ELECTRICAL ADDENDUM #1

Malady Head Concession Area Development

Terra Nova National Park

Issued September 19, 2019

TRENCH DETAIL "A"
SCALE : N.T.S.

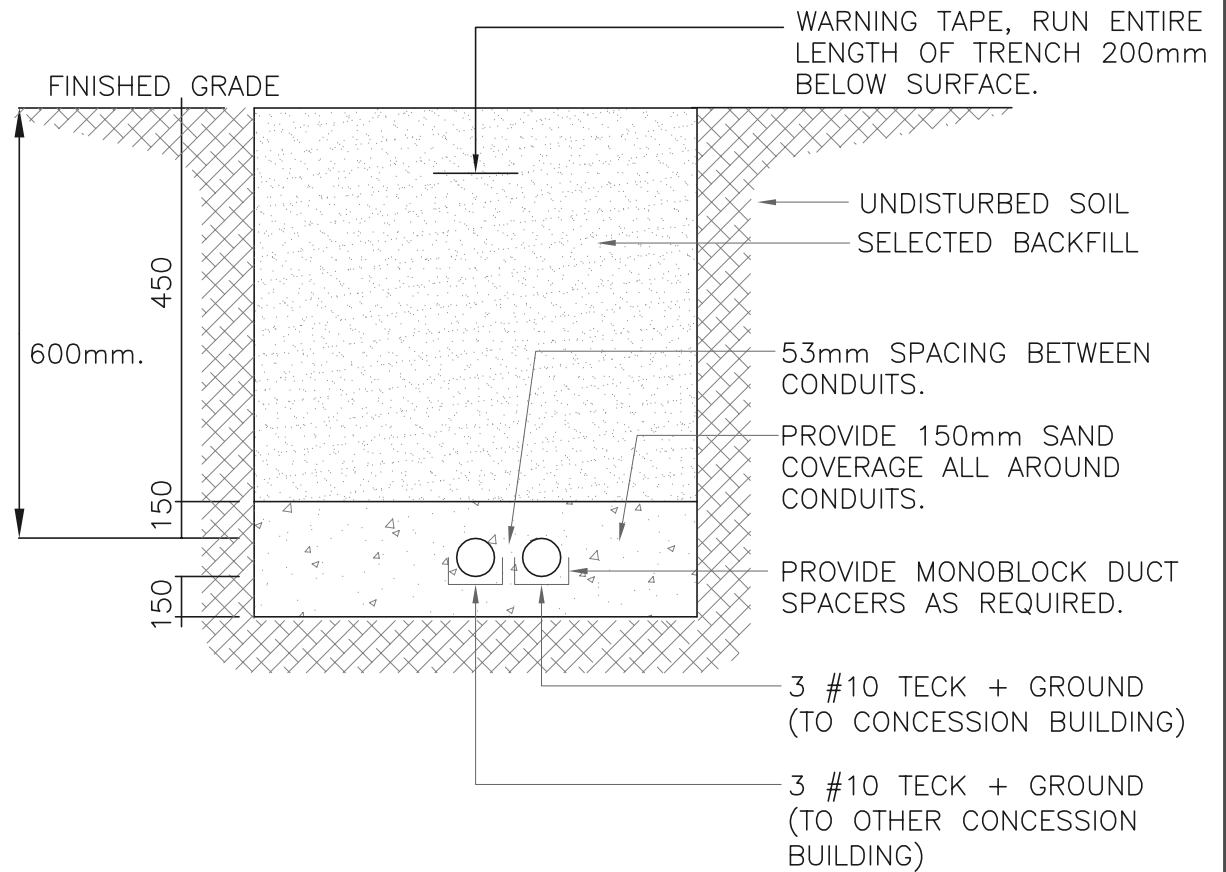
1. Reference schedule for Panel "A" within the existing kiosk building. Supply and install 30 Amp 2 pole circuit breakers (2 such) c/w mounting hardware, IC rating to match. Coordinate on site. Supply and install 30 Amp 240 Volt circuits (2 such) from Panel "A" within the existing kiosk building to the fused disconnect switches at the nearby concession buildings (3 #10 TECK + Ground for each circuit) via underground trench. See trench detail within attached sketch ESK-E1 for further details. Coordinate exact routing of trench on site with Civil and owner representative.
